Author(s): **Steve Virostek**
Soren Prestemon
Tapio Niinikoski
Date: **1/4/11**

TECHNICAL NOTE

**MICE Spectrometer Solenoid:
Modification and Repair Plan**

Figure 1: Preliminary layout of the modified cooler arrangement (5 ea 2-stage, 1 ea 1-stage)

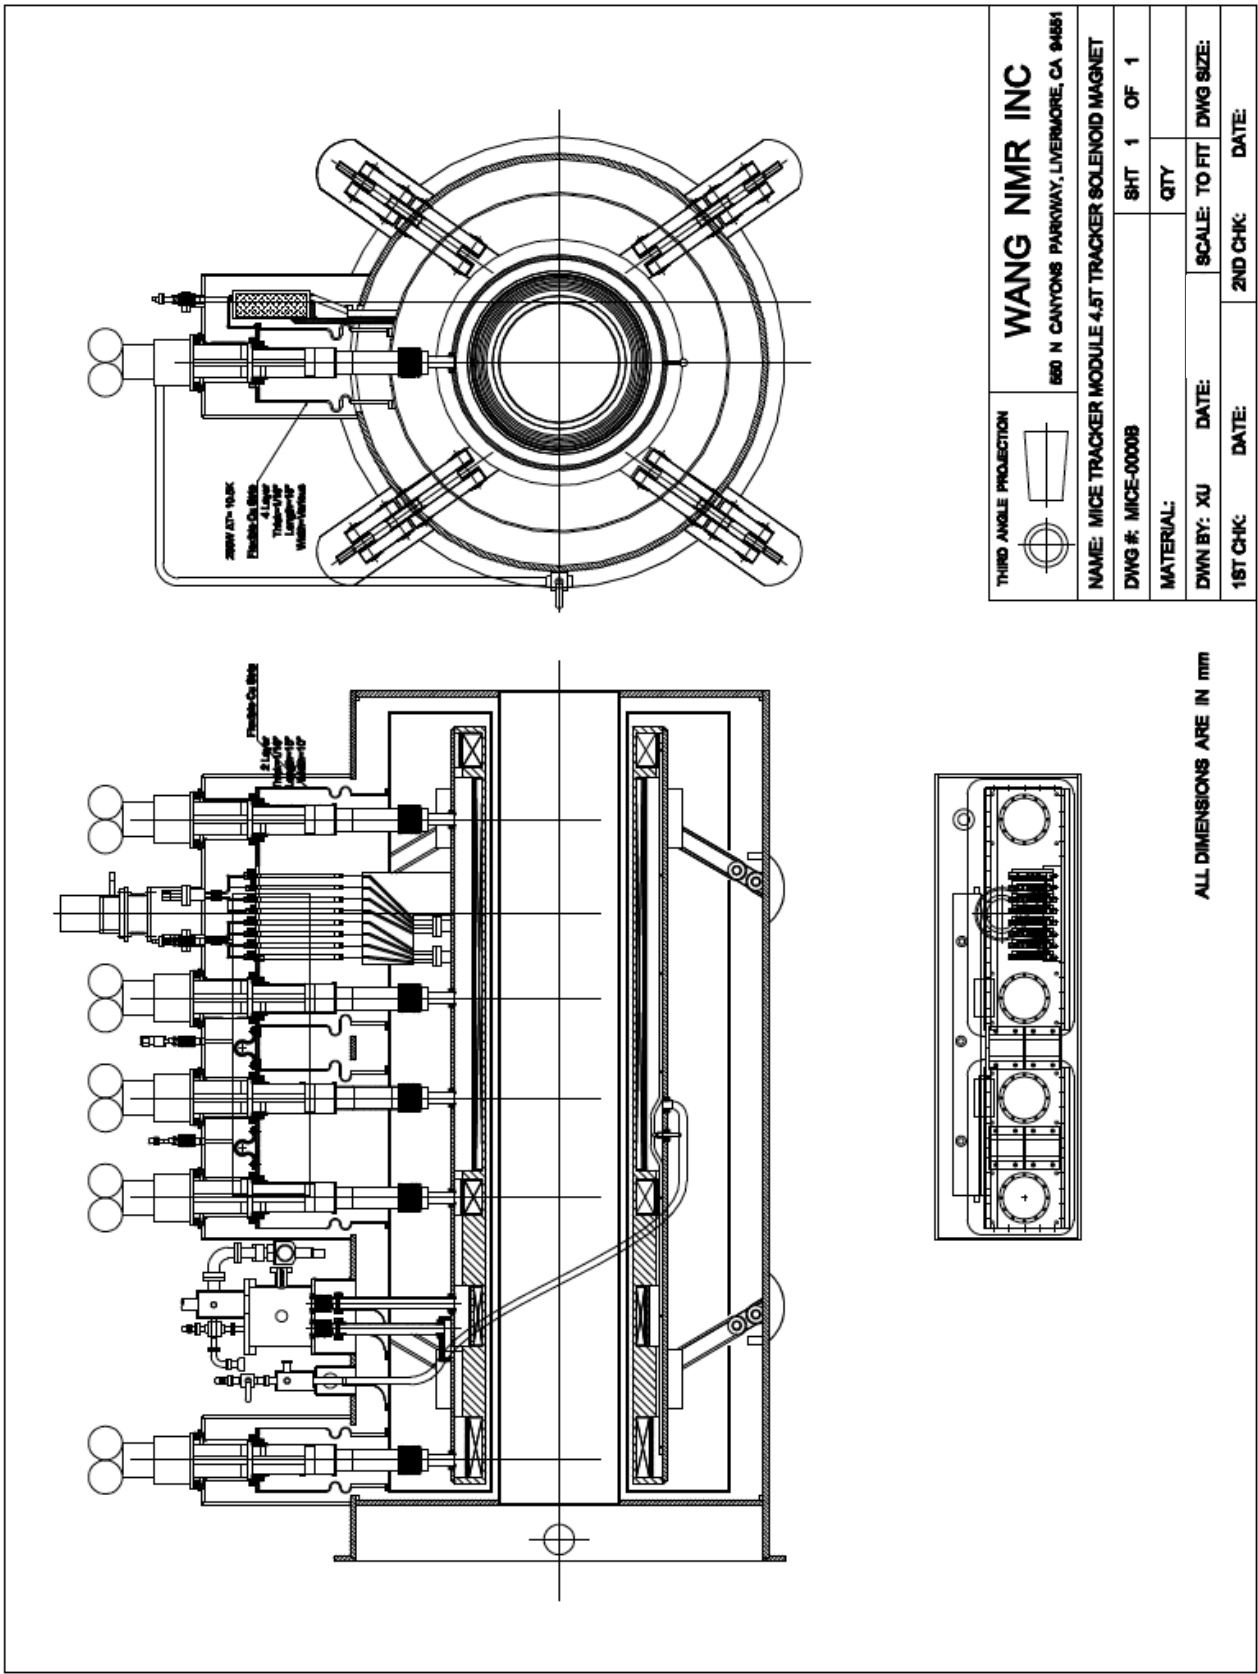
- The total cooling power will be increased by adding an additional pair of two-stage coolers to the Magnet 2B configuration. In total, each magnet will use five 2-stage pulsed tube coolers and one single-stage cooler. While it is possible that the system could run with fewer coolers after the previously described improvements have been incorporated, a greater margin on the cooling power will substantially reduce the risk and allow for possible degradation of the system over time. A layout of the proposed design showing the positions of the six cryocoolers is given in Figure 1. This drawing represents a preliminary layout produced by Wang NMR. The detail drawings required for carrying out this approach will be generated by the vendor once the plan has been approved.
